City Attorney's Office Opening Statement---City Exhibit #1---for court reporter

I (undersigned) support the APPEAL by the neighbors of the Haciendas del Mirasol development (2016-116 & 117)
 We ask the City Council to stop the project until adequate and complete planning and infrastructure design is provided as required by Chapter 14, the PRC zoning and City Ord. 1981-3

14-8.2 TERRAIN AND STORMWATER MANAGEMENT (Ord. No. 2011-37 § 10)

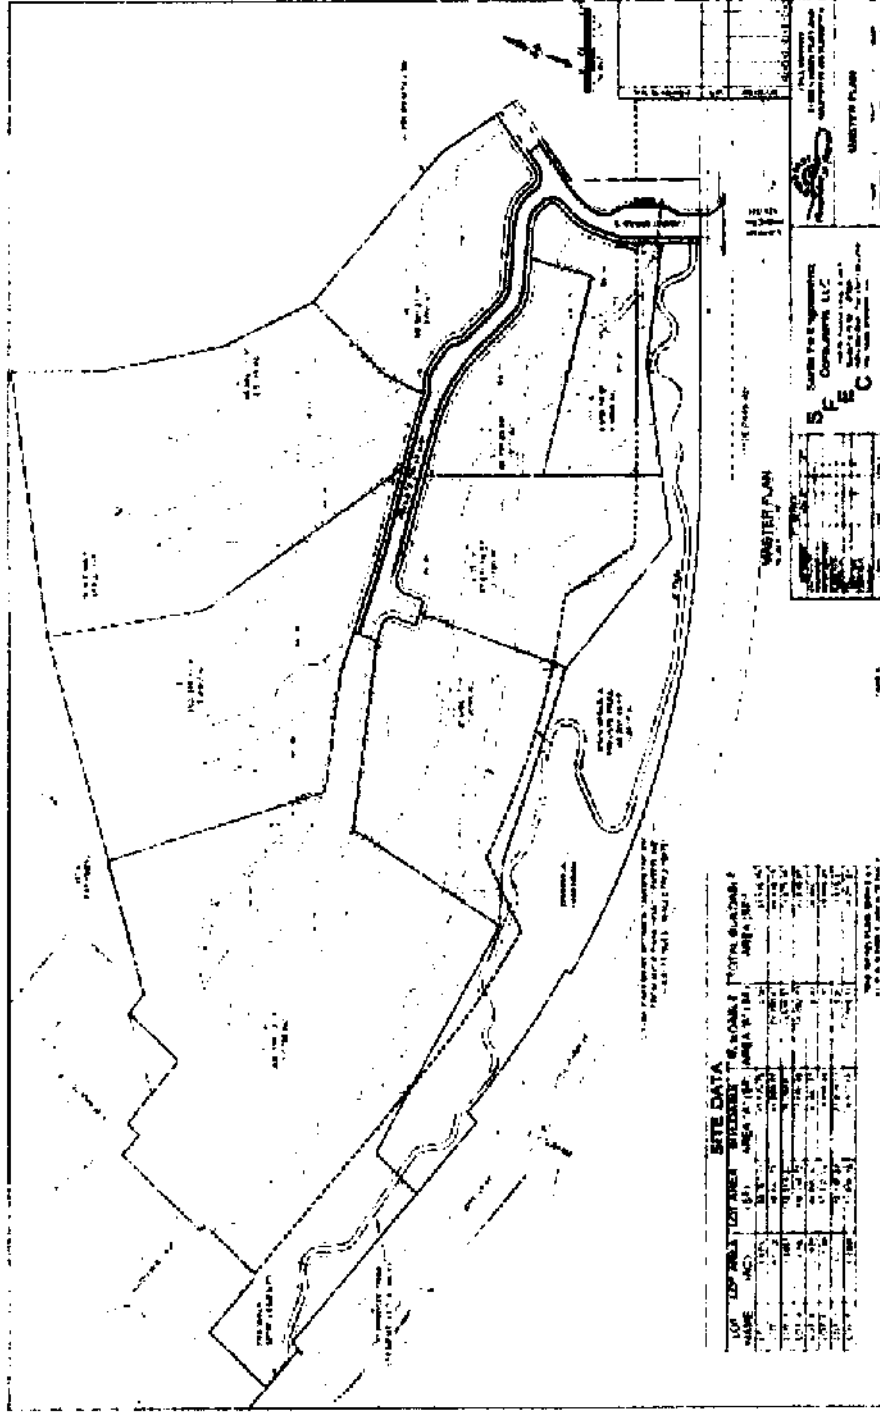
- A. The image shown above is the "700 HPR, LLC" Proposed Site Subdivision of Tract One into eight residential home lots. ("700 HPR, LLC" also proposes adjusting the NE corner boundaries of the existing Tract One for a proposed road to be extended to Tract Two.)

14-8.2 TERRAIN AND STORMWATER MANAGEMENT (Ord. No. 2011-37 § 10)

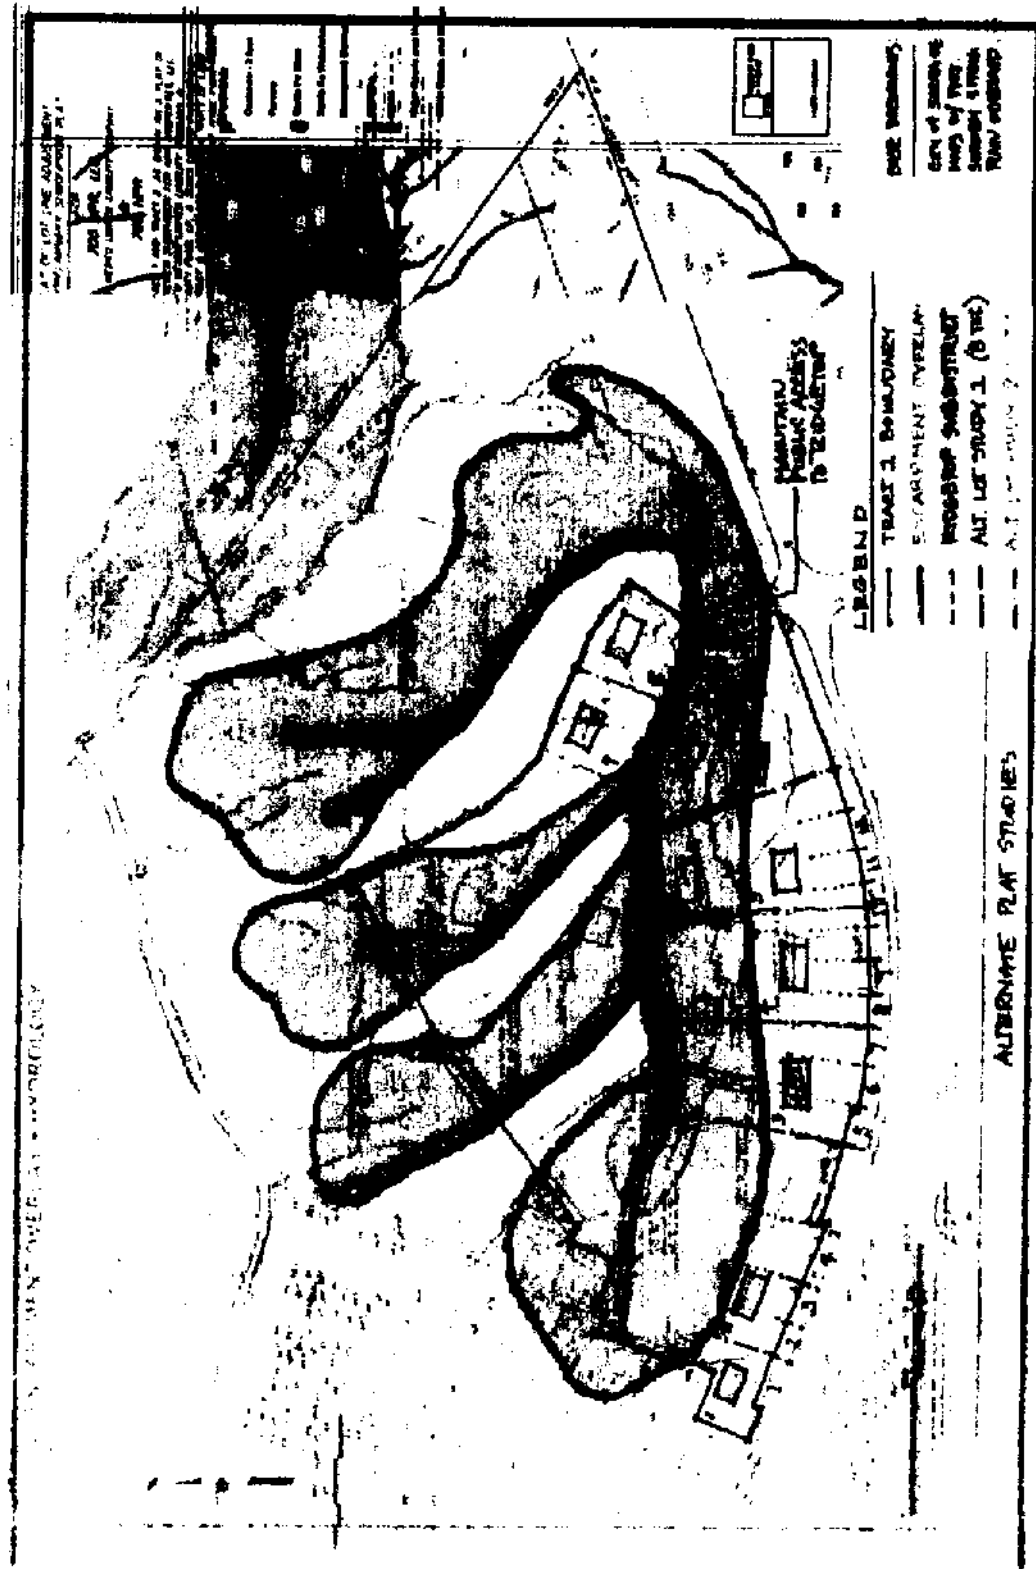
- A. The image above represents 8 large lots and 8 large house sites, (as well as an option for 12 smaller sites that would match the existing home lots to the west of Tract One).
- B. These alternative sites meet the City code definition of locating the home sites as far from the view line as possible, as well as preserving the "Ridgetop and Foothills sub-districts".
- C. This alternative plan preserves the intent of protection of the Escarpment Overlay District for the public at large.

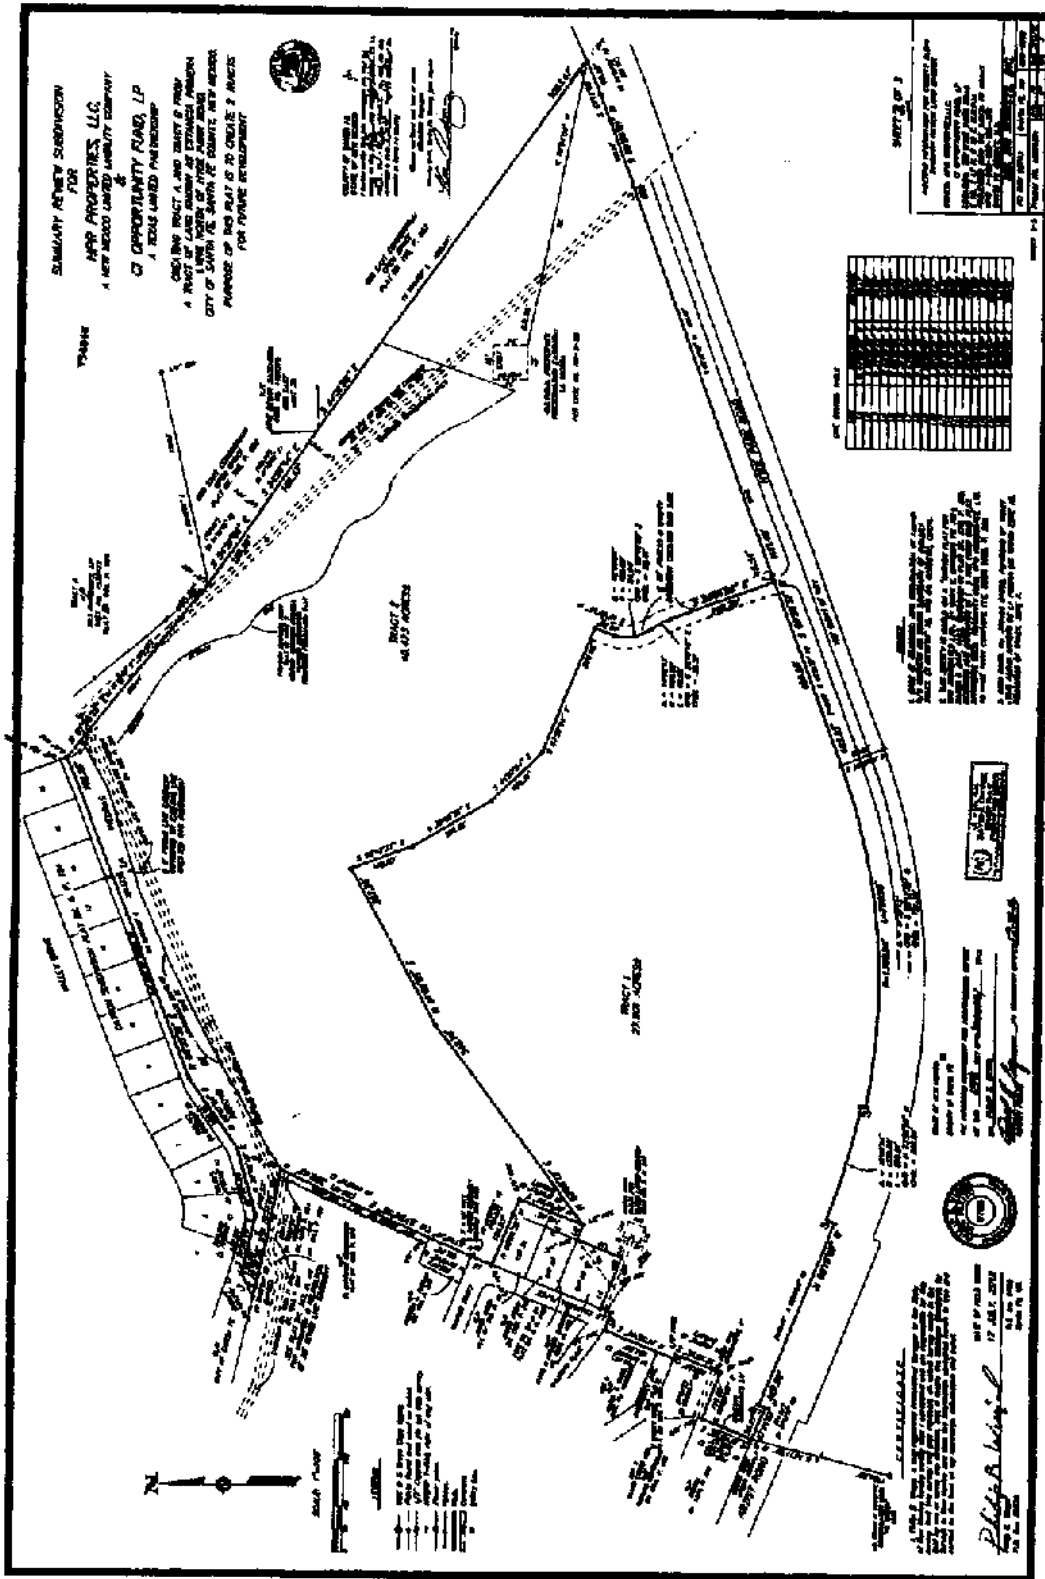
- A. The Google Aerial Photo shown above represents the historical pattern of homes abutting the street along Bishops Lodge Road and Artists Road.
- B. The street pattern of homes abutting the street continues throughout the historic district.
- C. The Estancia Primera development shows a new pattern from the 1980s, of homes pulled back from the edge of Artists Road and Hyde Park Road.
- D. Existing homes to the east (on Hyde Park Road) are constructed both along the road (historical pattern) and offset from the road (1980's pattern).
- E. The large native landscape in this photo is the proposed site subdivision called "Haciendas del Mirasol" within the "Escarpment Overlay District".
- F. The "Escarpment Overlay District is established in order to preserve the natural environment and the historic ridgetop and foothills environment".

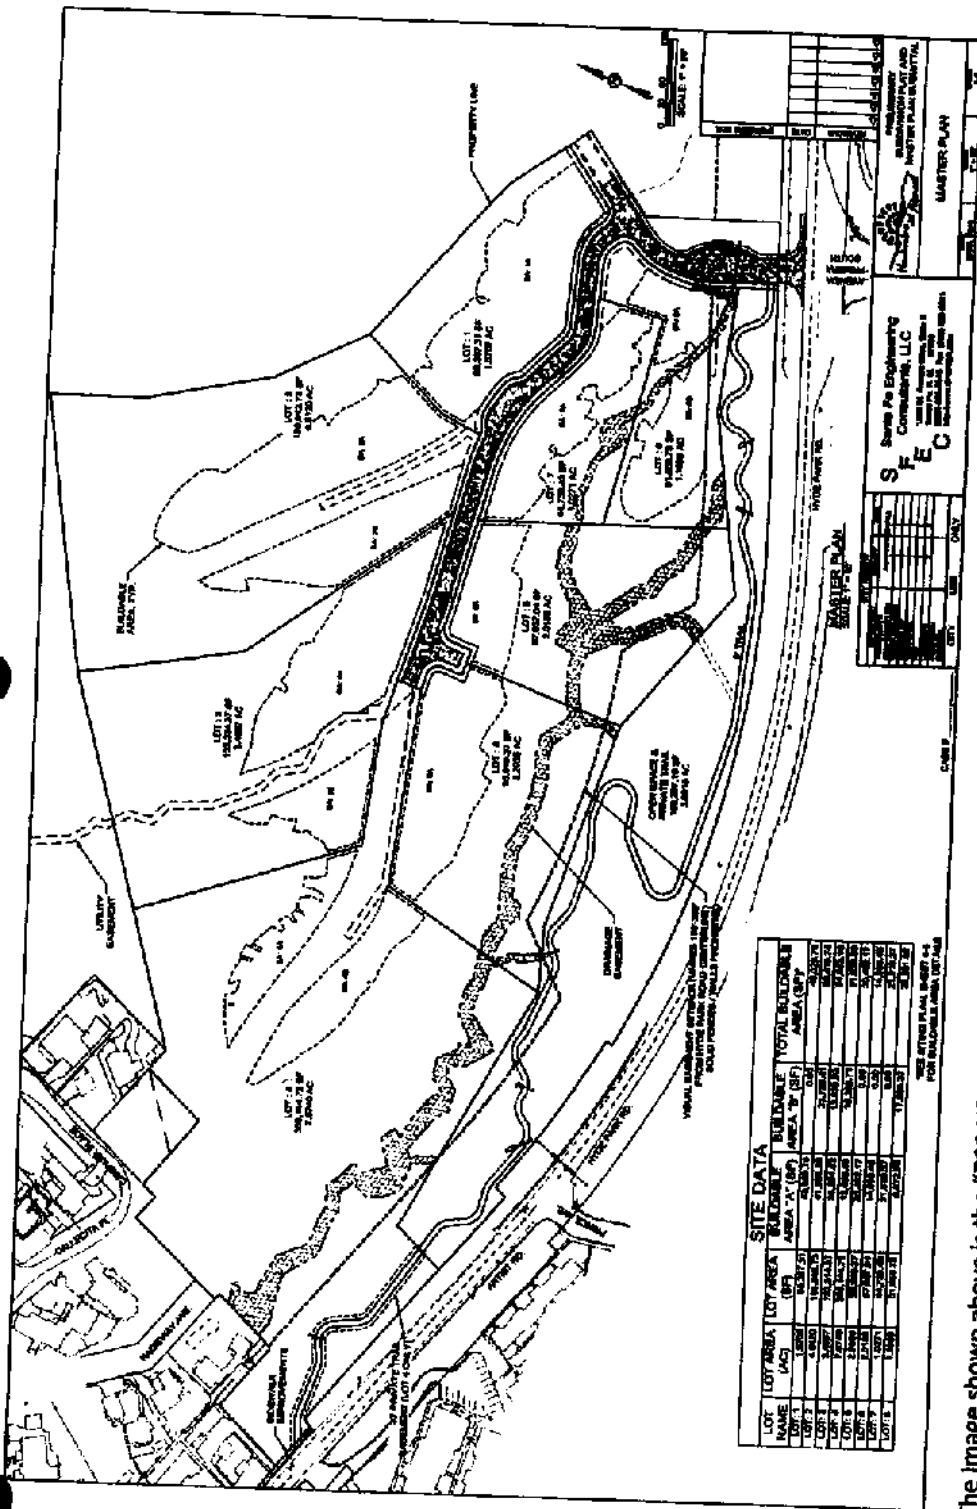
- Image shown above is the existing subdivision of the 68.374 acre site into Tract One (27.901 Acres) and Tract Two (40.473 acres).
- Tract One is the site currently under consideration for a proposed subdivision into eight lots by Cody North, the representative of "700 HPR, LLC".
- During the ENN, (and later with the proposed Master Plan submitted to the City) Cody North indicated roads would be provided across Tract One, to access Tract Two with 39 future lots. And the Traffic Impact Analysis states the intent to develop Tract Two with 39 homes (plus guest houses) during 2016-2017.
- You will notice above the existing survey of Tract One and Tract Two shows no required "Open Space" along the edge of Artist Road and Hyde Park Road.
- City Code also does not require "Open Space" along Artist Road and Hyde Park Road.
-
